KMR.CDD.BuQ.1918-1919.01

PLAN SHOWING PROPOSED ADDITIONAL
SHOPS TO THE MARKET ON PLOT NO 2

SHEET NO A-13

BUNDER Q_R

GROUND PLAN

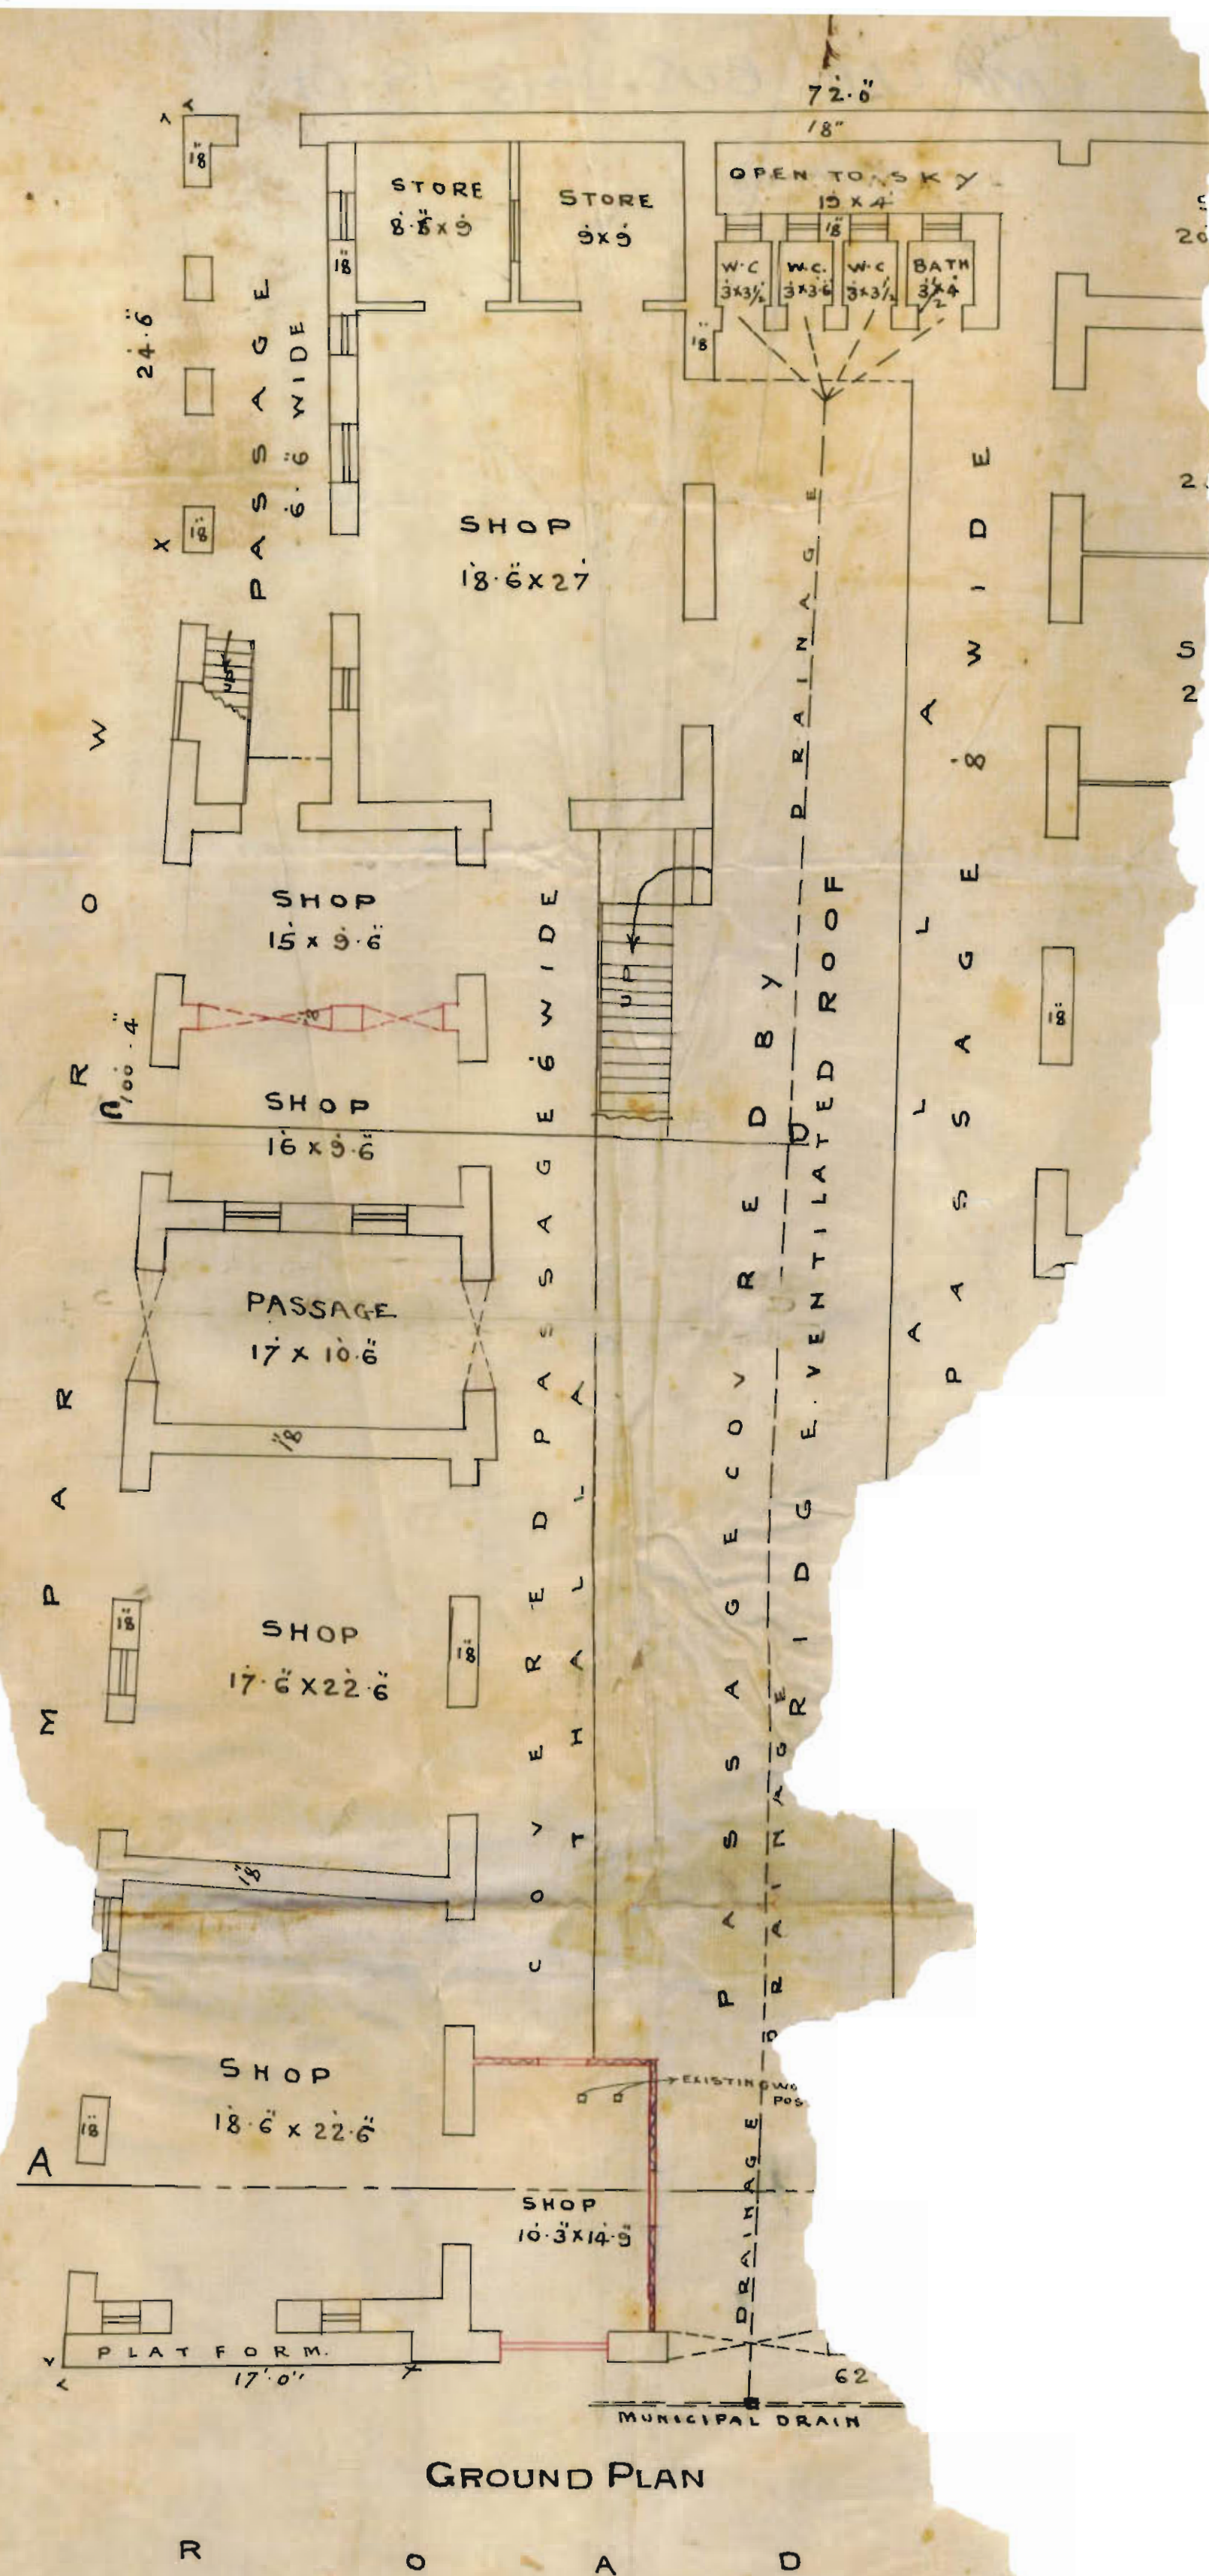
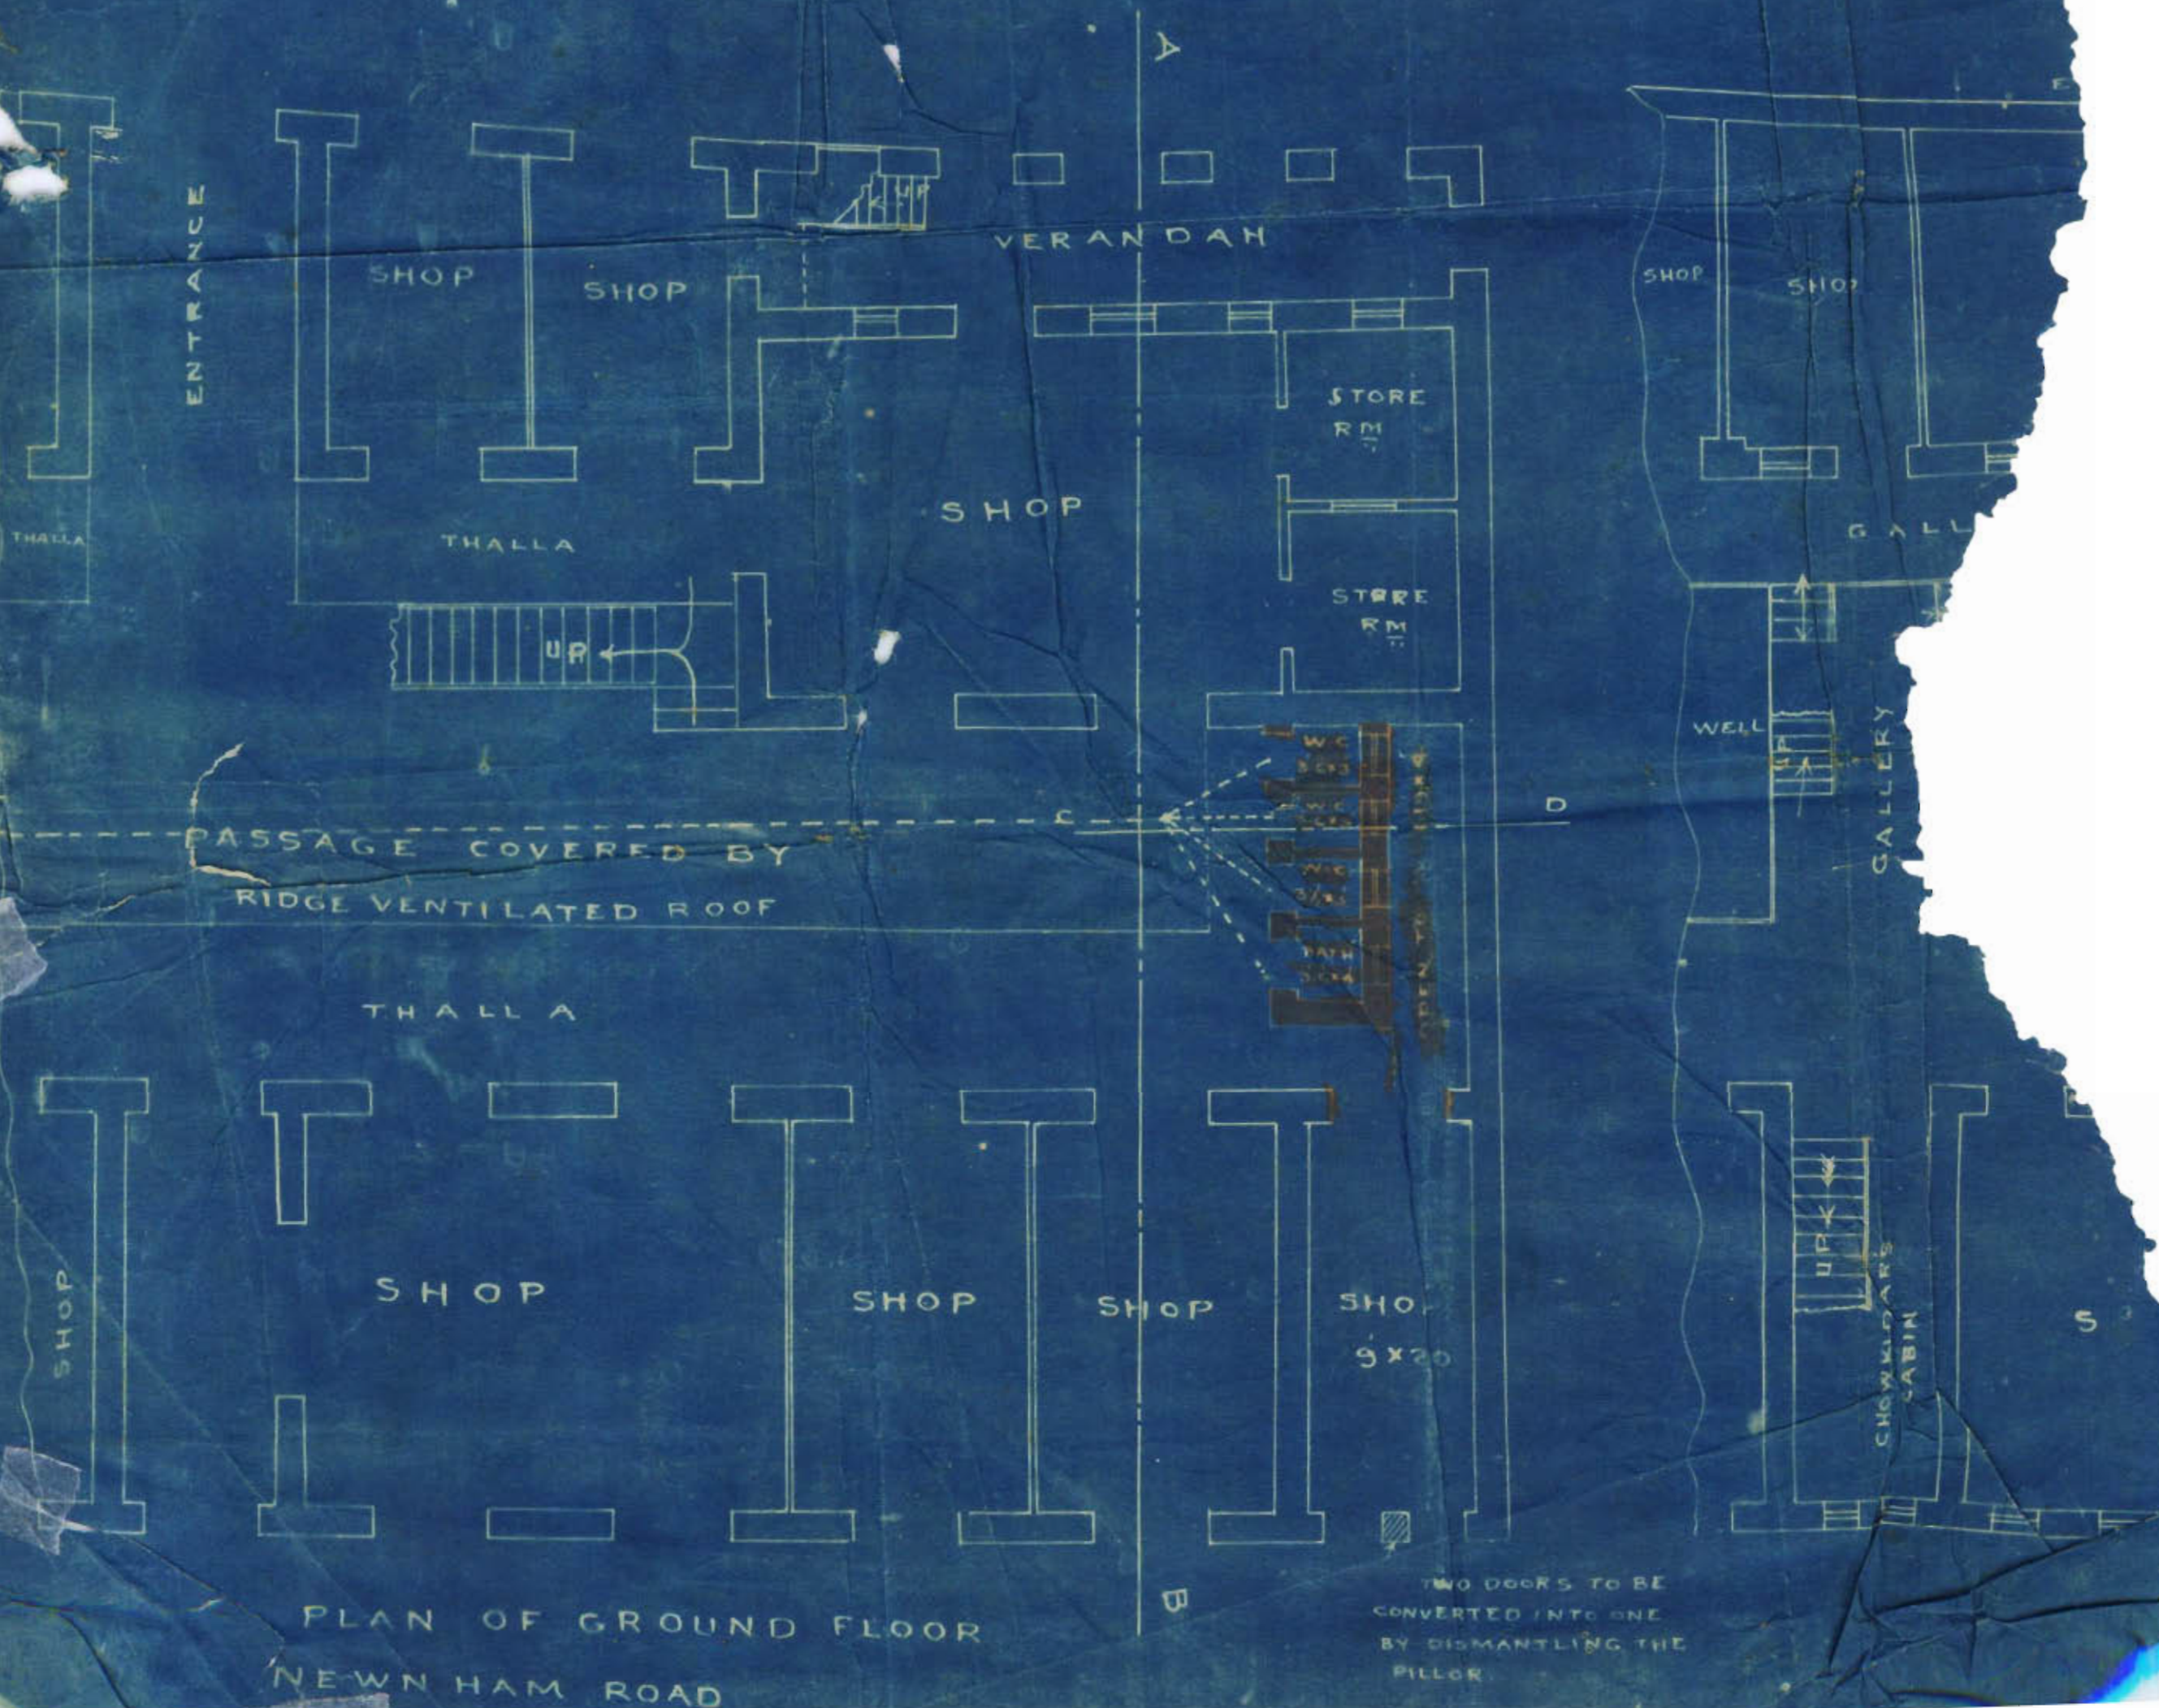
With reference to his additions and alterations to his building on plot No. 2.A-13 Bunder quarter Mr. Noormahomed Lallan is informed it is observed that he is deviating from the approved plan by reducing the number of water-closets and bath-rooms.

With reference to his additions
and alterations to his building on Plot No. 2 A/3
Bunder Dr. Mr. Noormahmad Lalani is
informed, it is observed that he is deviating
from the approved plan by reducing the number
of W.C.s & bath rooms.

With reference to his application dated 20th August 1918 with plans of the proposed shops to be built on plot No. 2.A-13 Bunder Quarter Mr. Nurmahomed Lallan is informed that permission to block up the present entrance which provides ventilation to the building cannot be permitted.

Permission to block up the present
entrance which provides ventilation
to the building cannot be permitted.
The plan is disapproved.
